Attached for your review is the *Response to Technical Comments and Data Gap Work Plan Addendum* for former Chevron-branded service station 91723, located at 9757 San Leandro Street in Oakland, California. This document was prepared by Stantec Consulting Services Inc. (Stantec), upon whose assistance and advice I have relied. I declare under penalty of perjury that the information and/or recommendations contained in the attached report are true and correct, to the best of my knowledge.

**Reference: Response to Technical Comments and Data Gap Work Plan Addendum**  
Former Chevron-Branded Service Station 91723  
9757 San Leandro Street, Oakland, CA

Subject: Request for Data Gap Work Plan Addendum; Fuel Leak Case No. RO0000412 and Geotracker Global ID T0600101789, Chevron #9-1723; 9757 San Leandro Street, Oakland, CA 94603

Figure 1 – Site Plan showing Proposed Soil Boring Locations

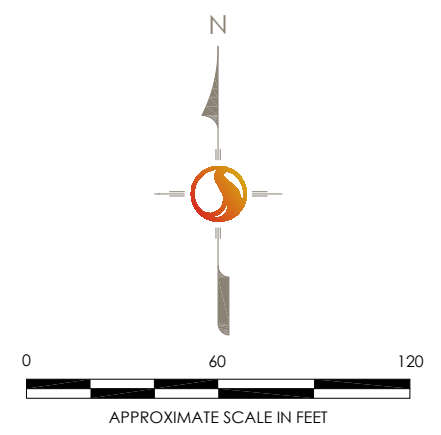
A former waste oil underground storage tank (UST) was previously located in the northwestern downgradient corner of the subject site. Soil bores SB3 and SB-4 were installed in the general location of the former UST; however, soil was only analyzed for Total Petroleum Hydrocarbons as gasoline (TPHg), benzene, toluene, ethylbenzene, and total xylenes (BTEX), and Total Oil and Grease (TOG). Other standard waste oil constituents were not analyzed for. This includes analysis for Total Petroleum Hydrocarbons as diesel (TPHd), volatile organic compounds (VOCs; full scan including BTEX, MTBE, TBA, naphthalene, and chlorinated hydrocarbons [HVOCs]), Semi-Volatile Organic Compounds (SVOCs; including polycyclic aromatic hydrocarbons [PAHs], pentachlorophenol, and creosote), wear metals, and polychlorinated biphenyls (PCBs). In contrast, groundwater from wells MW-1, MW-7, and MW-9, the only wells located downgradient of the former waste oil UST (as documented by the existing rose diagram, and the groundwater contour map included in the SCM [ Figure 3]), detected HVOCs up to 61.0 micrograms per liter ( $\mu\text{g/l}$ ) 1,1-dichloroethene, 9.5  $\mu\text{g/l}$  1,1-dichloroethane, and 93.1  $\mu\text{g/l}$  1,1,1-trichloroethane. Each of these concentrations exceeds the December 2013 Environmental Screening Levels (ESLs) for groundwater for these compounds as defined by the San Francisco Regional Water Quality Control Board (RWQCB).

Our review of the case files indicates that insufficient data collection and analysis has been presented to satisfy the media-specific criteria for direct contact and outdoor air exposure. Specifically, concentrations of benzene and / or ethylbenzene at a depth of 10 feet bgs in soil bores B-10 and B-15 fail the LTCP numeric goals for these contaminants. Concentrations up to 99 mg/kg benzene, and 150 mg/kg ethylbenzene were

Soil samples were not collected from borings SB-3 and SB-4 in the interval from 0 to 5 feet bgs due to low photoionization detector (PID) readings (1 and 39 parts per million [ppm], respectively). Based on these data, in the March 31, 2014 SCM, Stantec stated that no further assessment with respect to the potential waste oil release is warranted; however, to address ACEH concerns, Stantec proposes one soil boring to be advanced adjacent to but not within the former waste oil UST pit with a soil sample collected within the interval of 0 to 5 feet bgs to evaluate whether soil conditions in that interval meet LTCP direct contact and outdoor air criteria. Additional details regarding the proposed scope of work are provided in the work plan addendum section, and the location is shown on **Figure 1**.

*As described in the March 31, 2014 SCM, a soil sample was collected from borehole VP-3 in the same area as borings SB-10 and SB-15, within the same depth interval used to define LTCP direct contact and outdoor air criteria of 5 to 10 feet bgs, and concentrations of benzene and ethylbenzene in this sample were less than the limits specified in the LTCP. Borehole VP-3 is located approximately 10 feet from boring SB-10 and 5 feet from boring SB-15. Results from borehole VP-3 are more recent and are therefore considered more representative of current soil conditions. Based on these data, Stantec stated that no further assessment is warranted; however, to address ACEH concerns, Stantec proposes advancing one soil boring each adjacent to former borings SB-10 and SB-15 within the interval of 0 to 10 feet bgs to evaluate whether soil conditions in that interval near the former borings meet LTCP direct contact and outdoor air criteria. Additional details regarding the proposed scope of work are provided in the work plan addendum section, and the locations are shown on **Figure 1**.*

In addition to the scope of work for soil vapor investigation proposed in the March 31, 2014 SCM, Stantec is proposing the advancement of three shallow soil borings (SB-24, SB-25, and SB-26; shown on **Figure 1**) to evaluate petroleum hydrocarbons in soil near former fueling features. Results will be used to evaluate whether the Site meets the media-specific criteria set forth in the LTCP.
